Subject: UniStar Nuclear Energy, NRC Docket No. 52-016  
Response to Request for Additional Information for the  
Calvert Cliffs Nuclear Power Plant, Unit 3,  
RAI 286, Ultimate Heat Sink

**Response to NRC Request for Additional Information  
RAI 286, Question 09.02.05-18, Ultimate Heat Sink,  
Calvert Cliffs Nuclear Power Plant, Unit 3**

**Question 09.02.05-18**

Figure 9.2-7 - {Raw Water and Desalinated Water Supply}

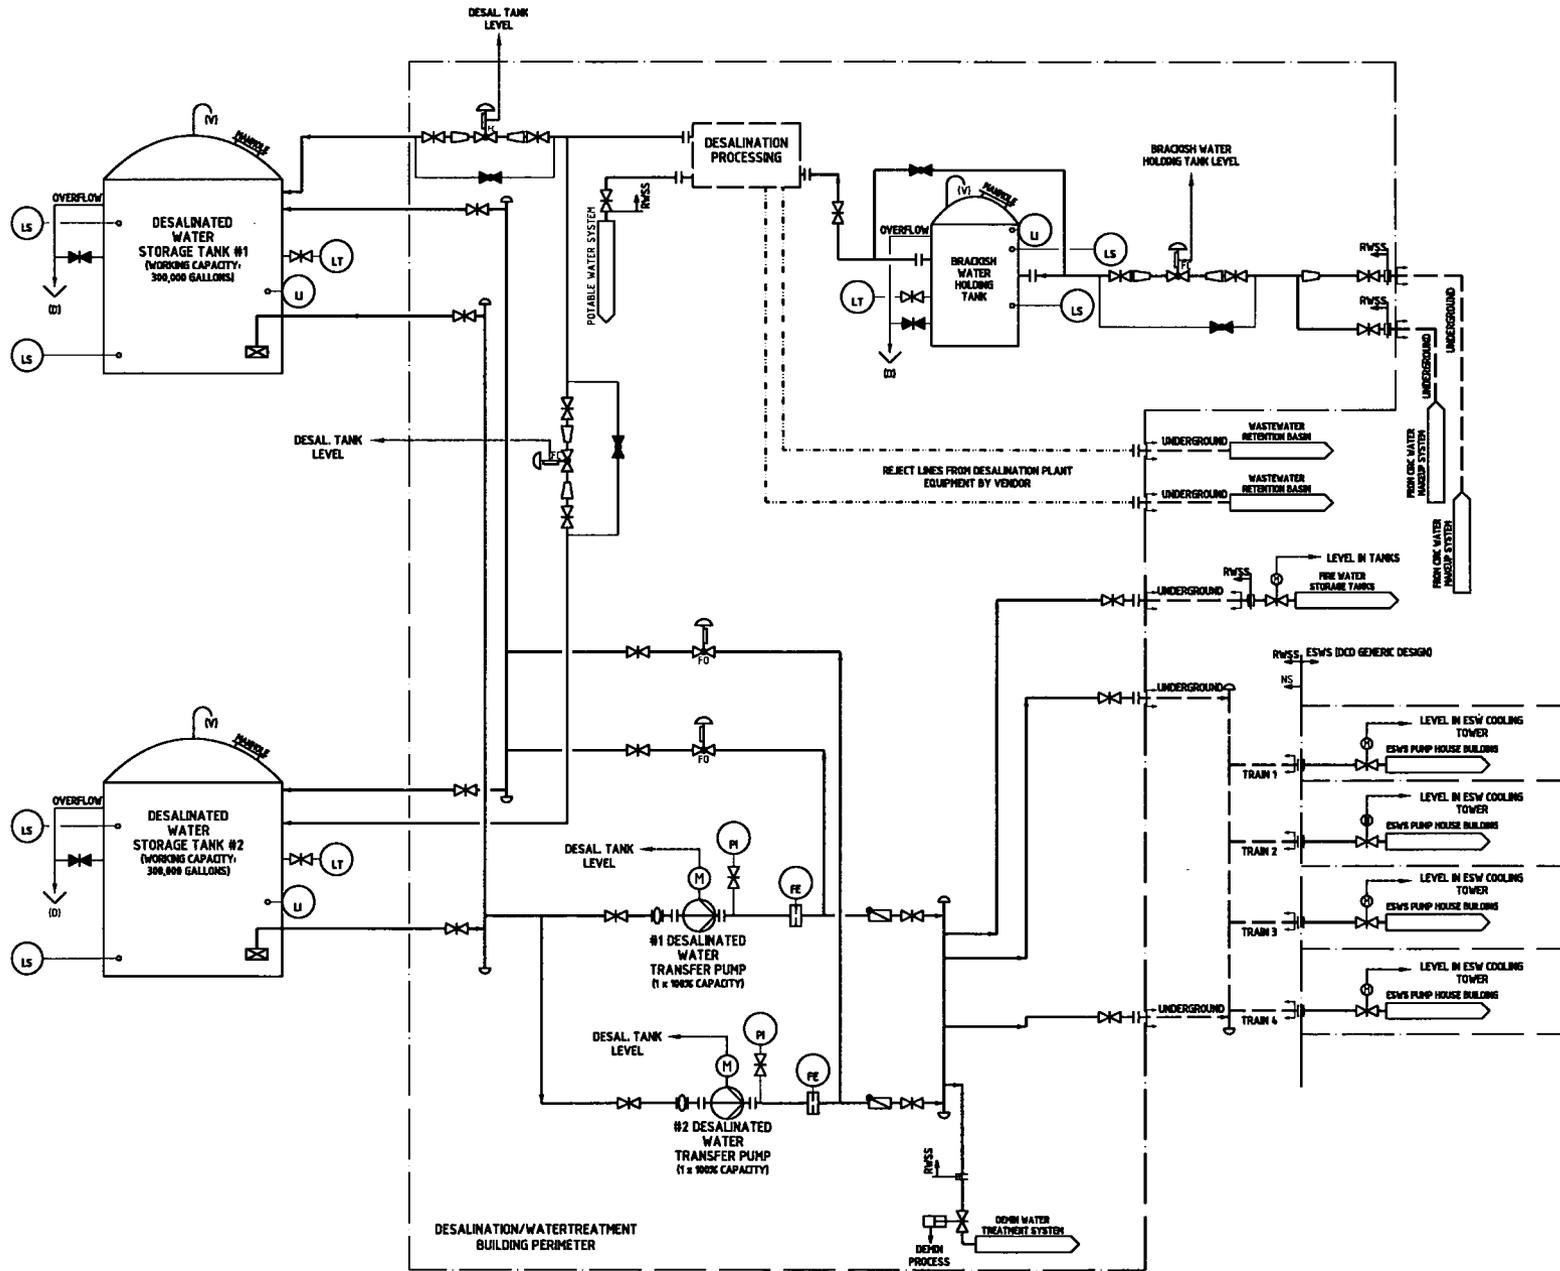
In response to the RAI, the applicant provided revised FSAR Figure 9.2-7, "Raw Water and Desalinated Water System," which indicates specific location of RWSS equipment and major isolation valves. However, the figure does not show the flow path to the potable water system. This conflicts with CCNPP Unit 3 FSAR Sections 9.2.9.2 and 9.2.9.3 which state that a second pair of 100% capacity pumps is provided for potable water demand. The applicant should provide information that reconciles this apparent conflict.

The revised FSAR Section 14.2.14.1 adequately describes the standby desalinated water transfer pump's automatic start upon sensing a low discharge pressure or upon the trip of the desalinated water transfer pump. The applicant stated in its response that Section 9.2.9.3 would be revised to remove the 'desalinated water transfer pumps - Potable Water.' However, this FSAR markup was not provided as part of the RAI response. Revision 7 of the COL FSAR states that "a second pair of 100% capacity pumps is provided for potable water demand". Therefore, this markup should be provided or provide a clarification to this statement from part 10 of this RAI response.

FSAR Figure 9.2-7 indicates a flow path to the Potable Water System from the desalination processing of the RWSS. The details of the Potable Water System, including two 100% capacity Potable Water Transfer Pumps, are shown in FSAR Figure 9.2-1.

In the response to CCNPP Unit 3 RAI 171, Question 09.02.05-2, bullet 10, the last paragraph is changed to read, "FSAR Figure 9.2-7 has also been revised to remove the 'desalinated water transfer pumps – Potable water', which are part of Potable and Sanitary water system and not part of the RWSS."

FSAR Figure 9.2-7 is being replaced with the following:
